1. Site Plan Review – J & H Family Store, 917 E. Main Street

CITY OF OWOSSO PLANNING COMMISSION STAFF REPORT

DATE: April 15, 2019
TO: Planning Commissioners
SUBJECT: Site Plan Request – 917 E. Main Street, Parcel # 050-112-000-034-00

SITE AND UTILITY PLAN
J&H FAMILY STORE
917 E. MAIN ST.

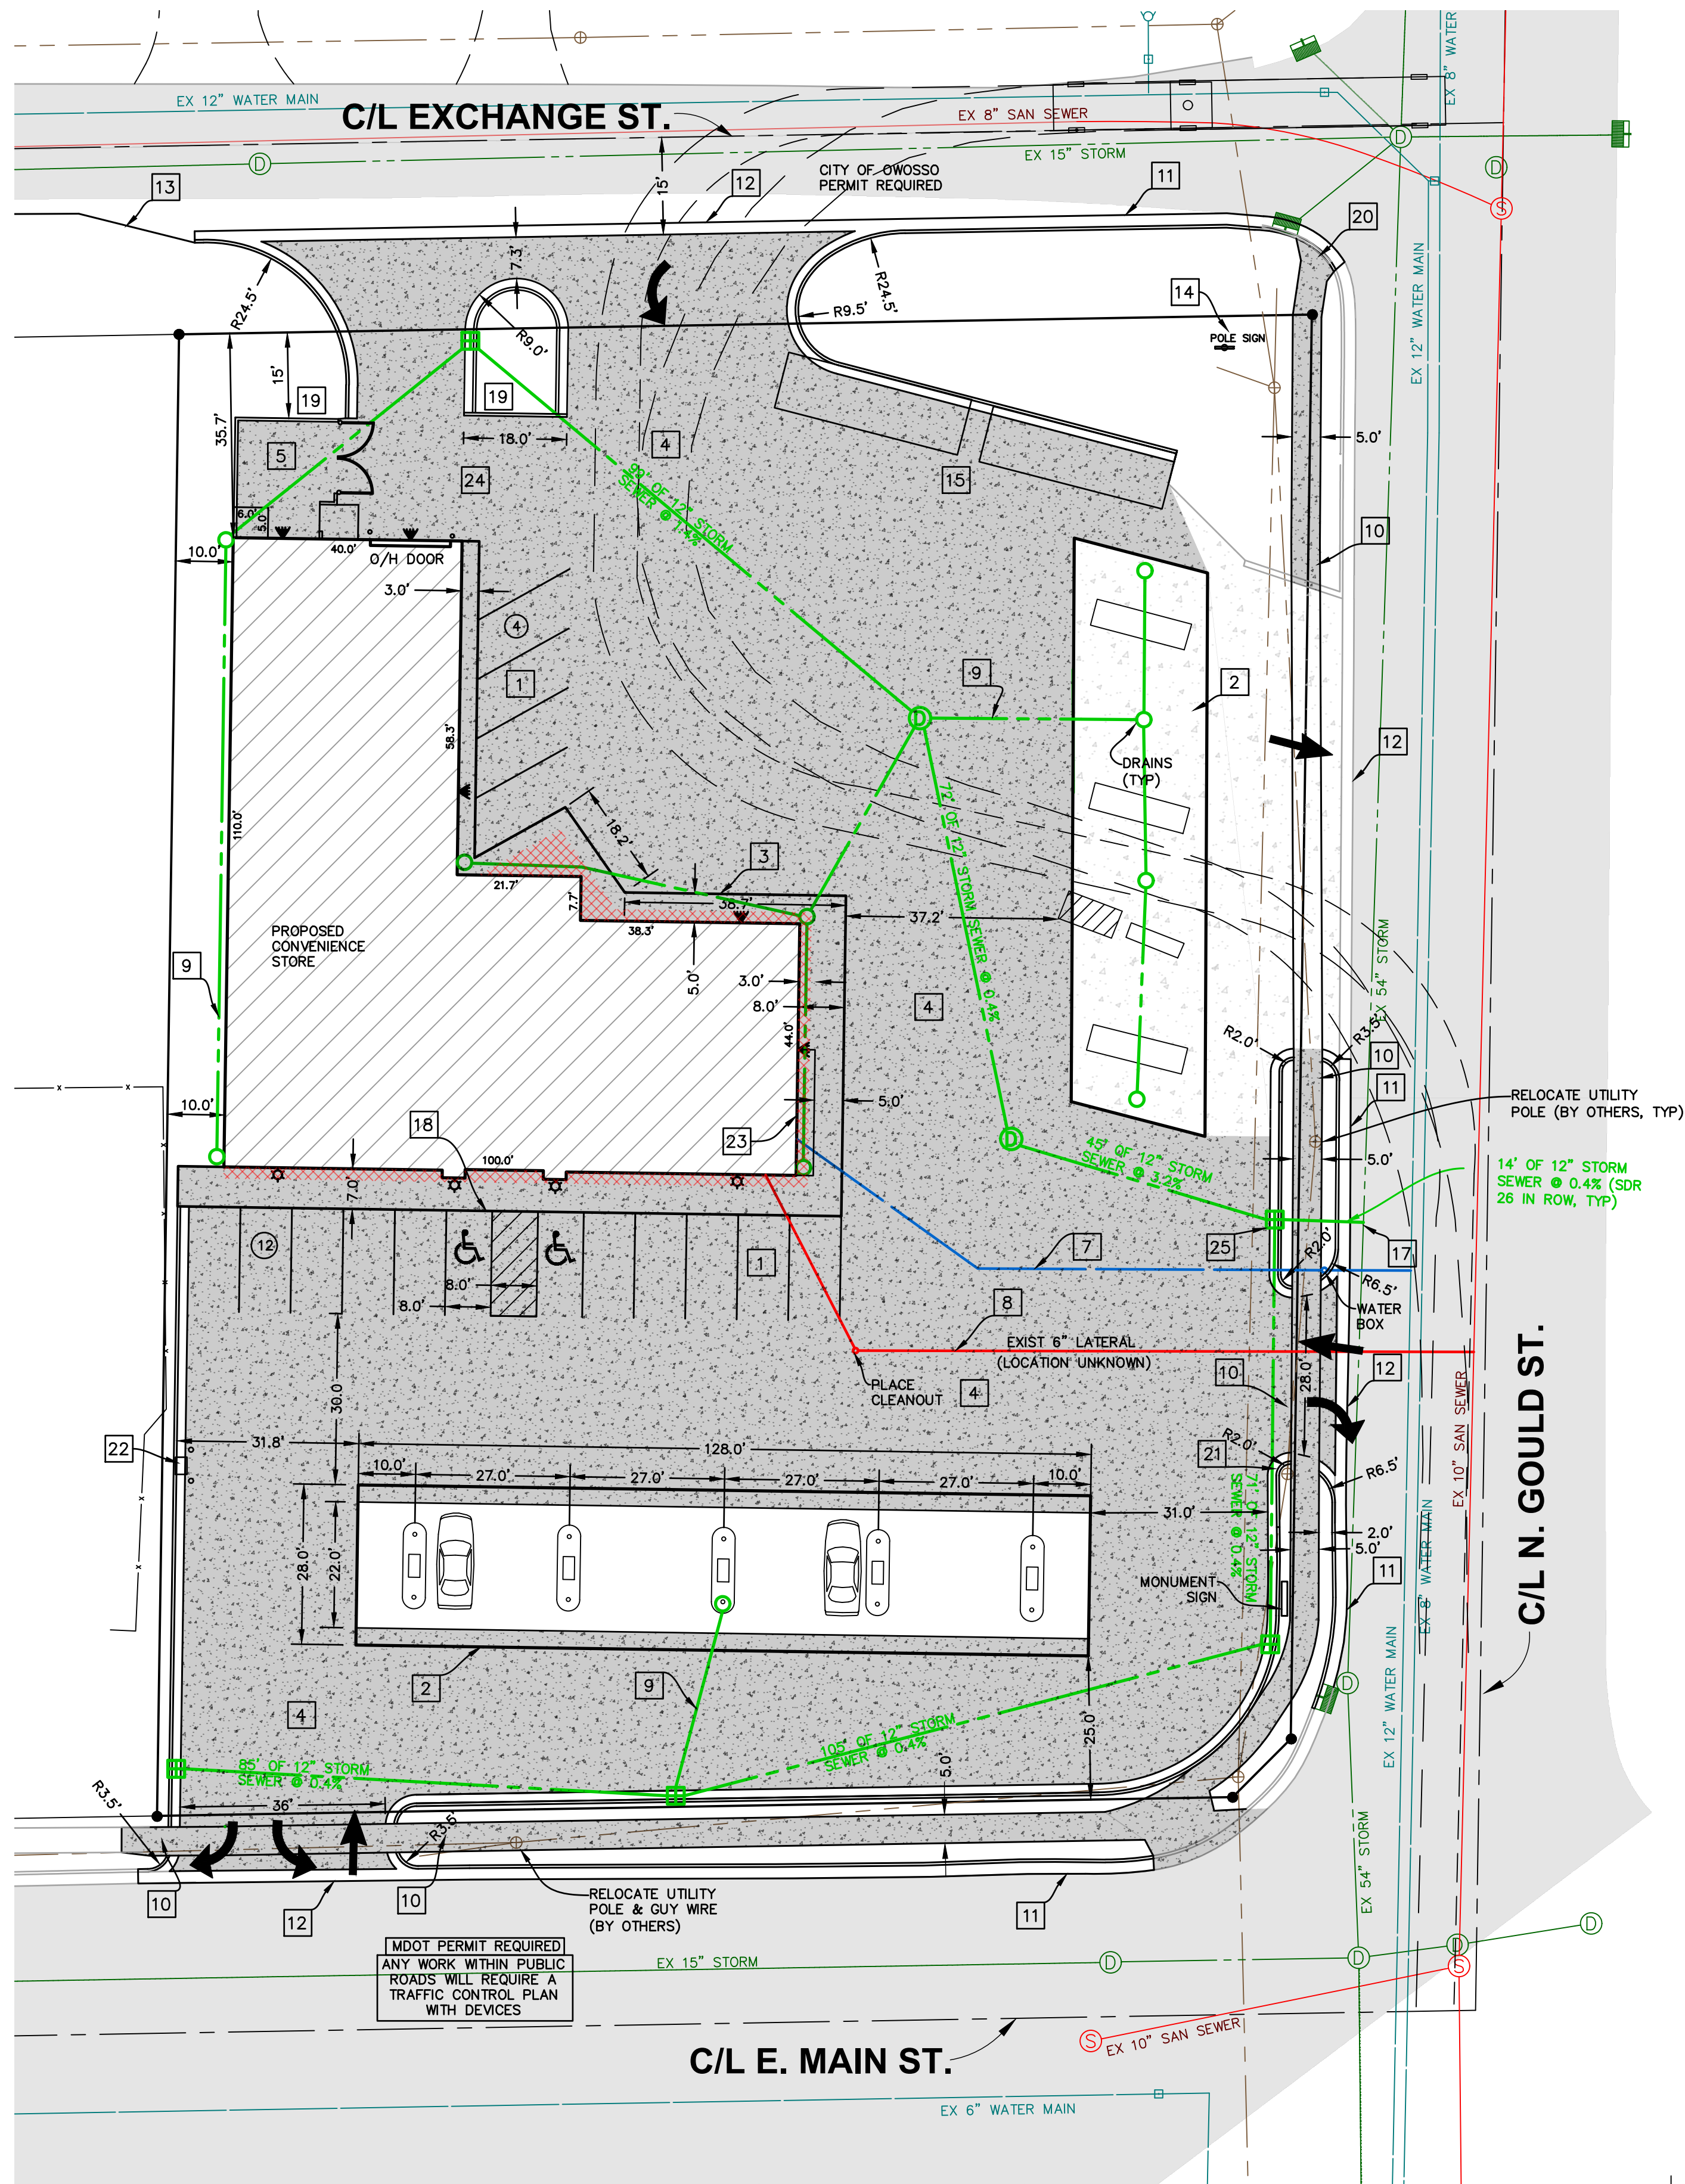
5. Revise the parking space size to meet Sec. 38-381 (2) Level of Service A.
6. The aisle width provided between the car at the gas pump and the curb west of the southernmost canopy is not wide enough for two-way traffic. The width needs to reflect a two-way traffic aisle width.

9. Provide stamped architectural drawings.
10. Remove the dumpster enclosure details provided on sheet C3. The details conflict with the details provided on Sheet A4.01. Dumpster must meet front yard setback requirements.

11. Show any proposed exterior sales locations (i.e. propane cage, washer fluid, etc.) on the plan. It must meet the requirements of Sec.38-399 (f).
12. Pole signs are currently not permitted in the City. The moving and re-use of the pole sign will require a variance.

21. Exchange Street requires City of Owosso access approval. Please revise the plans accordingly.
22. The access point on Exchange Street should be reduced to have less of an impact on the adjacent residentially zoned properties.
23. The access point on N. Gould Street should be reduced to provide less chances of conflicting traffic patterns.
24. Please provide the stripping for the access points (turn lanes, in, out, etc.).

3. All site storm drainage must be contained on site, especially with fuel station, and that it is in flood zone. Some perimeter grades at drive openings must be modified to ensure site drainage is contained on site and not allowed to spill over public sidewalk.

4. Proposed storm drainage system is shallow with no outfall. Their plan is to use leaching basins and perforated storm sewer material. The system is inadequate and must be redesigned such that storm sewer is constructed below frost line, use standard concrete structures, and designed with outfall into 54" storm sewer along Gould Street. Connection must have manhole located somewhere immediately west of 54" storm sewer and Kor-N-Seal tap (rubber connector) into storm sewer; Inserta Tee connection also acceptable; this type connection was done at Qdoba development and product information may be in our files. Roof drains should be tied into the storm sewer.

9. Special note regarding proposed sidewalk work along Gould Street; there is public sidewalk (see cover sheet) along west side of Gould Street at Exchange Street. That public sidewalk must be completed across the development site and connect with public sidewalk at Main Street. The plans should be modified to incorporate this connecting sidewalk.

10. All sidewalk constructed across drive openings must be constructed on even plane across the opening ensuring pedestrian right-of-way and safety (no ramps allowed across openings); and cannot be uninterrupted by curb and gutter. All sidewalk shall be minimum 5 feet wide (plans note 4 feet) so as to meet ADA standards.

- 13] BITUMINOUS PAVEMENT (SEE DETAIL)
- 14] VARIANCE REQUEST FOR NEW POLE SIGN, 5' SOUTH OF ROW LINE (SEE REQUIREMENT #4)
- 15] 10' X 33' FUEL TANKS
- 16] LITHONIA MODEL OLAW23 OUTDOOR LIGHT, 10 5000K LEDS POWERED BY A 120 VOLT DRIVER USING 35 INPUT WATTS PROVIDING 1200 DELIVERED LUMENS, 50,000 HOUR AVERAGE LED LIFE
LITHONIA MODEL DSXOLED 40C 1000 40K T3M MVOLT SPA DDBXD 40 LEDS 1000mA DRIVE CURRENT, 4000K COLOR TEMPERATURE, SQUARE POLE MOUNT WITH A DARK BRONZE FINISH
